Access Compliance Report

Public Rights-of-Way

Intersection ID: 51046	Main Street: LONGNOR_ST	Cross Street: PALATINE_LN	Location: SE
ADA ID: 50C91891F2BE	Ramp Type: PerpDiag	Initial Pass/Fail: Pass	Overall Compliance: No
		Severity Score: 5.25

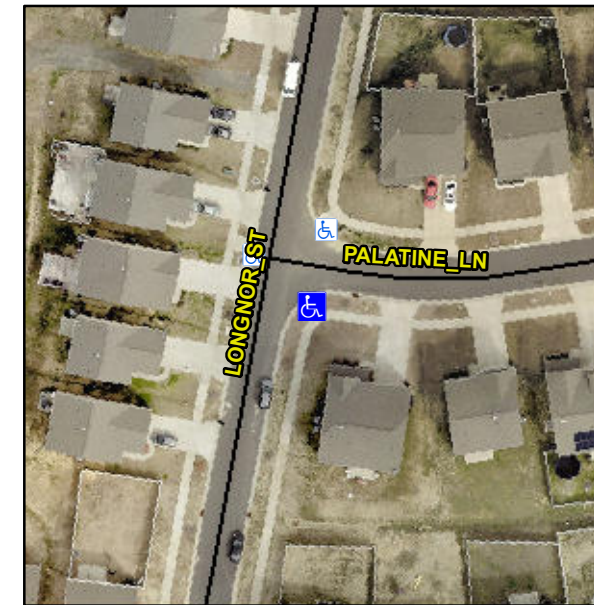
R304.5.3, R304.2.3, R305.2

Compliance	Description	Data	Compliance	Description	Data
N/A	Ramp Length (in)	96.0	Yes	Ramp Slope (%)	7.0
Yes	Ramp Width (in)	60.5	No	Ramp XSlope (%)	3.6
N/A	Flare Type LT	Sloped	N/A	Flare Type RT	N/A
N/A	Flare Slope LT (%)	12.5	Yes	Flare Slope RT (%)	7.5
N/A	Flare Traversable LT?	Yes	N/A	Flare Traversable RT?	Yes
Yes	Landing Length (in)	59.5	Yes	DWS Provided?	Yes
Yes	Landing Width (in)	60.0	Yes	DWS Contrast?	Yes
Yes	Landing Slope (%)	1.4	Yes	DWS Length (in)	24.0
Yes	Landing X Slope (%)	1.1	Yes	DWS Full Width?	Yes
N/A	Landing Curb? (Y/N)	No	No	DWS Offset (in)	5.0
N/A	Shared Landing?	No			
Yes	Gutter Ponding?	No	Yes	Gutter Slope (%)	5.0
Yes	Gutter Lip Ht (in)	0.0	No	Gutter X Slope (%)	4.0
N/A	Painted X Walk1?	No	N/A	Painted X Walk2?	No
	X Walk 1 Direction	To N		X Walk 2 Direction	To W
N/A	X Walk 1 Width (in)	N/A	N/A	X Walk 2 Width (in)	N/A
	X Walk 1 Slope (%)	2.8		X Walk 2 Slope (%)	0.2
	X Walk 1 X Slope (%)	1.3		X Walk 2 X Slope (%)	4.2

Remove & Replace Curb Ramp With Two New Directional Ramps or Equivalent. Remove & Replace Gutter.
